**Change Nr, Title** 20008236, Improve dimension for housing  
**Date of issue** 14.03.2022

Adjustment of the housing dimension.

SAMPLE VIEW FN9233E

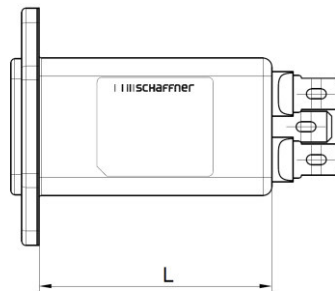
Update housing dimension to gurarantee all time high quality and appearance of the finished products.

Dimension L increasing according to table below, performance remains the same.

DESCRIPTION	OLD HOUSING DIMENSION [MM]	NEW HOUSING DIMENSION [MM]
FN9222Exx-SERIES	46.8	47.1
FN9222EU-SERIES	46.7	47.1
FN9233Exx-SERIES	46.8	47.1
FN9233EU-SERIES	46.7	47.1
FN9244Exx-SERIES	46.8	47.1
FN9244EU-SERIES	46.7	47.1
